third & virginia II, LLC

ankrom moisan
architects

MUP # 3003187
10.13.2009

Per our discussions with DPD staff over the past few weeks, we have submitted a request to revise our previously approved MUP. The purpose of this request is to address a necessary departure regarding the ratio of parking stall sizes in our project. The only revision we are requesting to the MUP is the addition of a departure that was not included in the original MUP. We look forward to discussing this issue further with you are the design commission hearing.

SIMPLIFIED PLAN
NOT TO SCALE

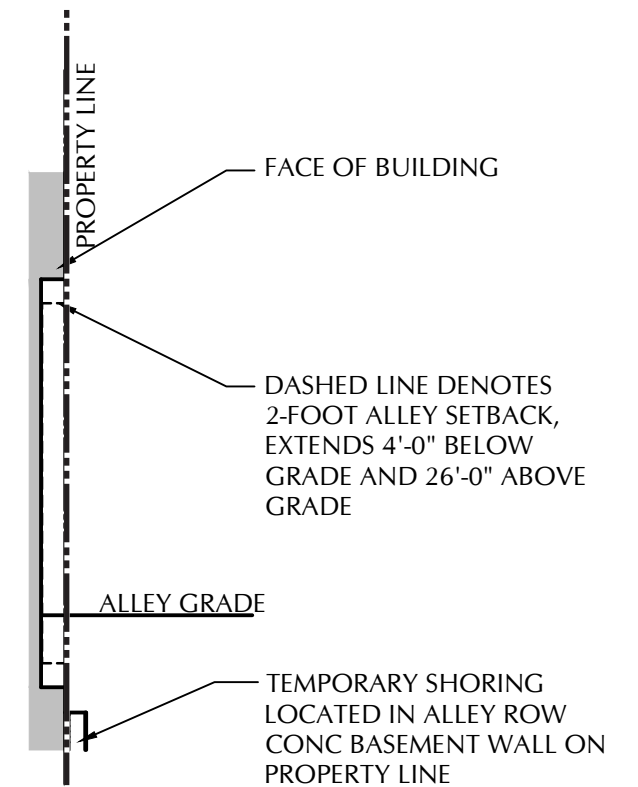
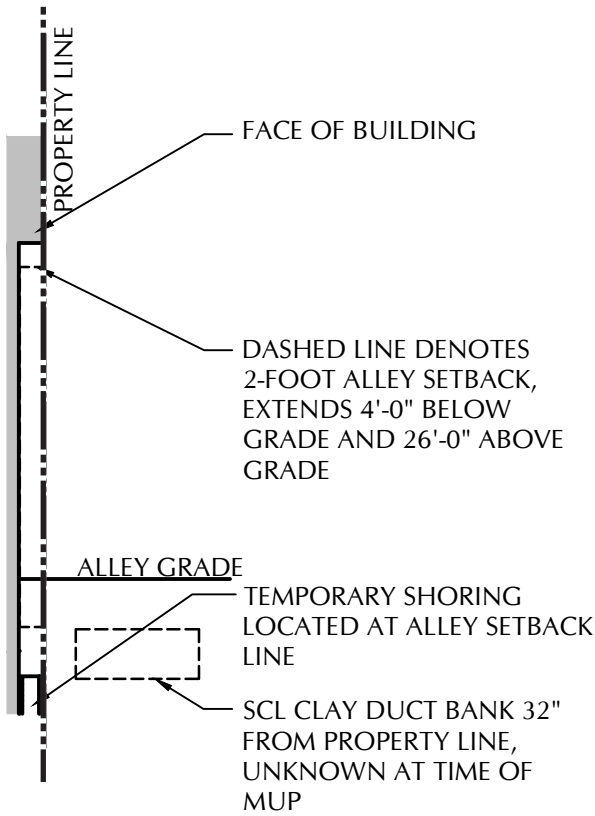
At the time the MUP documents were prepared the project team made a number of assumptions on the location of the shored basement walls and the size of the structural systems (columns, shear walls, and basement retaining walls). After the MUP issuance and during the development of our construction documents it was clear that some of these assumptions needed to be revised. Ultimately the structural systems on the parking floors grew to their current size. Additionally, while coordinating the shoring design with Seattle City Light it was determined that there were a number of old clay duct banks 32” from the property line under the alley. Locating the shored wall as shown in the MUP documents (at the property line) was strongly not recommended by SCL and would have been extremely difficult and risky during construction. We ultimately modified the shoring design to locate the shored wall at the 2-foot dedication line as apposed to the property line as shown in the MUP. Combined, these items resulted in a reduction of the overall parking garage dimension of 2’-8” in the east-west direction. This reduction made it impossible to match the layout shown in the MUP submittal. Although the revised project would continue to meet minimum drive aisle standards, the reduced aisle width results in fewer medium sized spaces being provided, and thus the new departure request.

In order to address the 2’-8” reduction we re-designed the structural systems and moved the building core to maximize drive aisles. By relocating the building core we were able to maintain a 20-foot aisle (as required for small stalls) on the east side, but were forced to reduce the western aisle by 1’-11” to 20’-2”. In the MUP documents the western aisle met the 22-foot requirement for medium stalls and therefore contained the majority of the medium parking stalls.

Reduction of the parking size ratio as required by SMC 23.54.030.B.1.b to:

1. A minimum of 25% of the parking spaces shall be striped for medium vehicles, instead of the 60% required minimum, and;
2. 75% of the parking spaces may be striped for any size, instead of the 40% striped for any size. Please note that 35% of the total number of spaces will be for medium and large stalls, so the garage will still have a mix of stalls available.
